Access Compliance Report Public Rights-of-Way (Curb Ramps)

Main Street: E_ORANGE_GROVE_AVE Cross Street: N_COLBY_ST Location: NW

ADA ID: RPAT211020085305 Ramp Type: Type 1 - Perpendicular Diagonal Initial Pass/Fail: Fail Overall Compliance: No Severity Score: 20

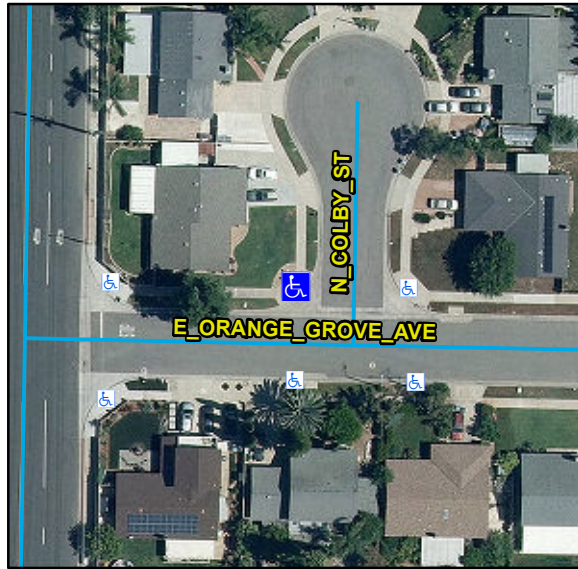
Compliance	Description	Data	Compliance	Description	Data
N/A	Ramp Length (in)	74	N/A	Flare Type LT	
No	Ramp Width (in)	46			N/A
No	Ramp Run Slope (%)	10.5	N/A	Flare Slope LT (%)	N/A
Yes	Ramp Cross Slope (%)	1.6	N/A	Flare Traversable LT	N/A
N/A	Landing Present	N/A	N/A	Flare Type RT	
N/A	Landing Length (in)	N/A			N/A
N/A	Landing Width (in)	N/A	N/A	Flare Slope RT (%)	N/A
N/A	Landing Run Slope (%)	N/A	N/A	Flare Traversable RT	N/A
N/A	Landing Cross Slope (%)	N/A	N/A	DWS Provided	N/A
N/A	Landing Movement Obstructed?	N/A	N/A	DWS Contrast	N/A
	Landing Movement Type	N/A	N/A	DWS Length (in)	N/A
N/A	Landing Shared	N/A	N/A	DWS Full Width	N/A
N/A	Clear Space	Yes	N/A	DWS Offset Left (in)	N/A
N/A	Clear Space To Crosswalk (in)	N/A	N/A	DWS Offset Right (in)	N/A
N/A	Marked Crosswalk 1	No	N/A	Marked Crosswalk 2	No
	Crossing 1 Direction	S		Crossing 2 Direction	E
	Marked Crosswalk 1 Width (in)	N/A		Marked Crosswalk 2 Width (in)	N/A

Remove & Replace Curb Ramp With Two New Directional Ramps or Equivalent.
